Report: TAB Report

Function: Test, Adjust, & Balance

Date: 09/23/2025

06-09-25 WAWA #6305 WAYCROSS, GA

Issue Name : EF1-1and EF4-4 have wrong diffuser type installed

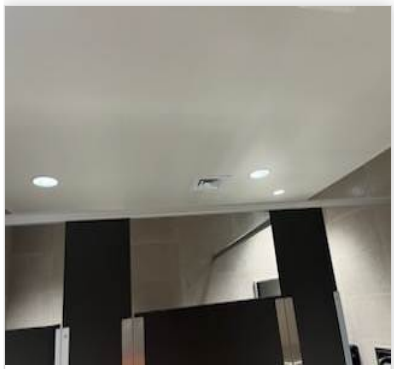
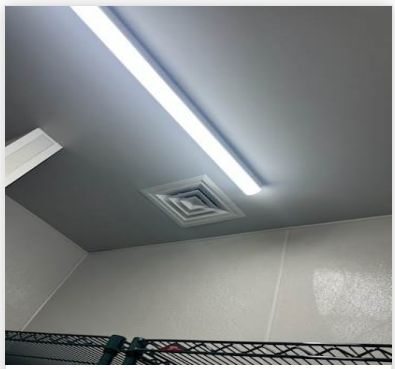
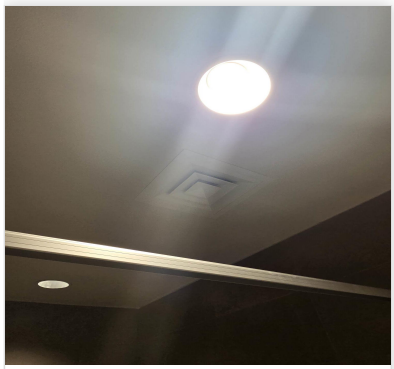
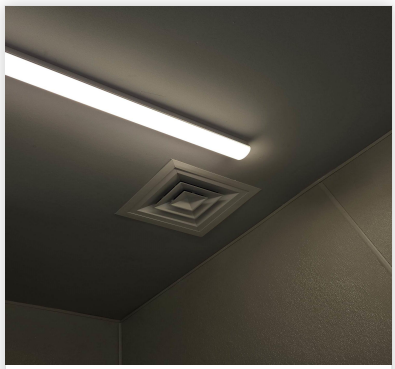
Description : Currently installed are CD-4 supply diffusers when GRD calls for G-3 exhaust diffusers.

- **11/07/2025 National TAB - Stephen Tassinaro**
  - Supply type diffusers still installed on exhaust.

- **09/23/2025 National TAB - Stephen Tassinaro**
  - Unresolved 9/22.
- **06/30/2025 National TAB - Ian Fuller**
  - Issue not resolved as of 6/30. Supply type diffusers still installed.

Issue Name : RTU-1 humidity sensor

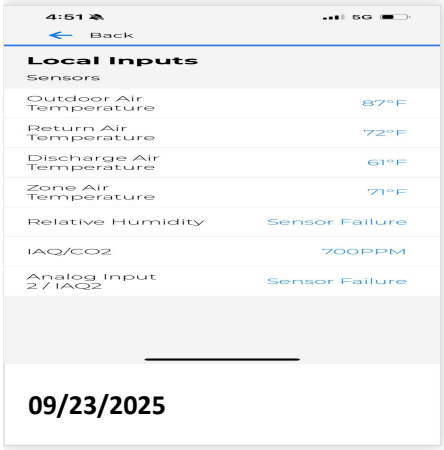
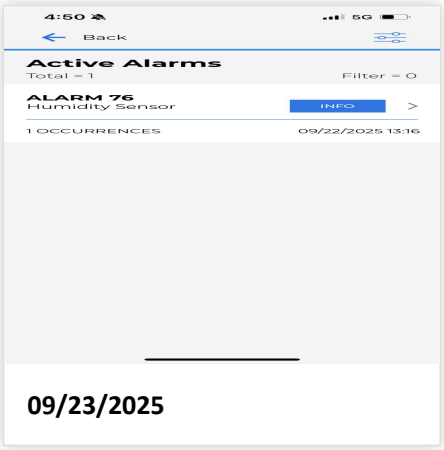
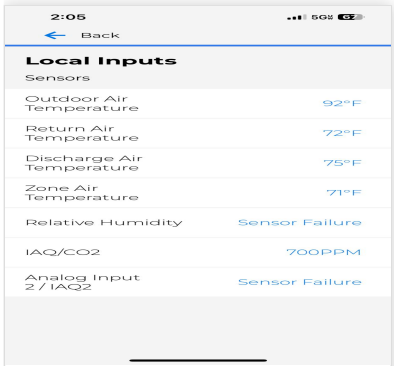
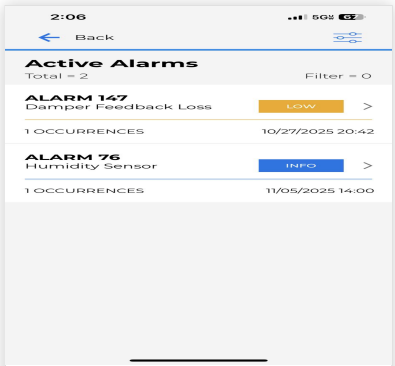
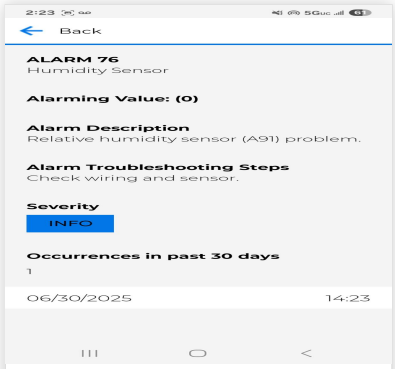
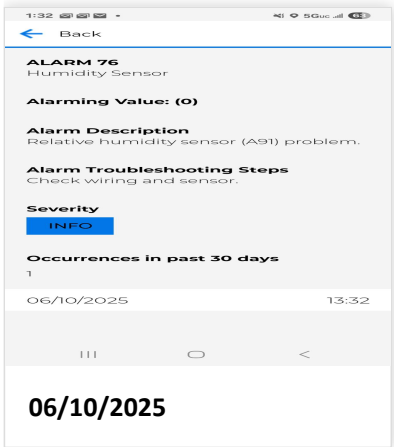
Description : Humidity sensor is not reading correct humidity. Sensor starts to read at 8% then jumps to around 35% when humidity in the building is around 53 % RH. Humidity sensor wiring is per spec. VERIFY ALL THREE UNITS ARE READING A REALISTIC RELATIVE HUMIDITY IN ORDER TO CLOSE ISSUE.

- **11/07/2025 National TAB - Stephen Tassinaro**
  - Sensor still reading between 8% and then sensor failure. Likely a short in the wiring or terminals landed incorrectly.

- **09/23/2025 National TAB - Stephen Tassinaro**
  - RTU-1 is still alarming for humidity sensor. Unresolved.

- **06/30/2025 National TAB - Ian Fuller**
  - Issue nit resolved as of 6/30. Core alarm is still present on system.

Issue Name : Smoke detector dust plugs are still in unit
Description : Recommended to remove dust plugs in all units before store operation.

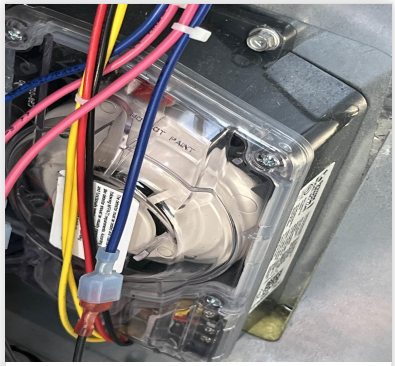
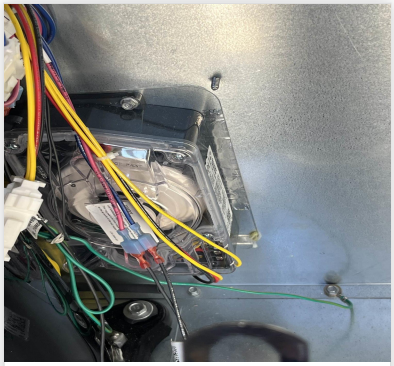
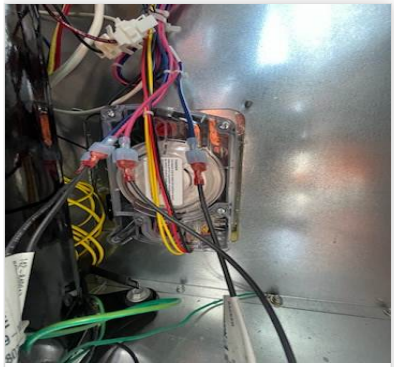
- **11/07/2025 National TAB - Stephen Tassinaro**
  - Dust plugs still installed on return side smoke detector heads.

- **09/23/2025 National TAB - Stephen Tassinaro**
  - Unresolved 9/22.

- **06/30/2025 National TAB - Ian Fuller**
  - Issue not resolved as of 6/30.

Issue Name : Transfer duct in vestibule has wrong diffuser installed.

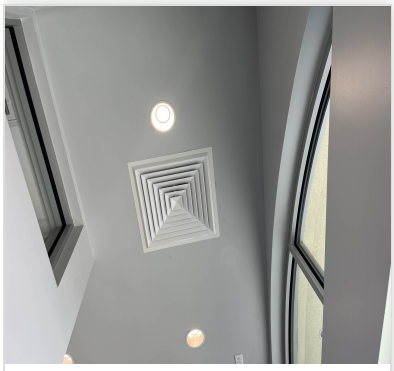
Description : A supply type CD-2 diffuser is installed when the GRD specifies a return type G-2 diffuser is installed. The correct diffuser type needs to be installed.

- **11/07/2025 National TAB - Stephen Tassinaro**
  - Supply type diffuser still installed on vestibule transfer grille.

- **09/23/2025 National TAB - Stephen Tassinaro**
  - Unresolved 9/22.
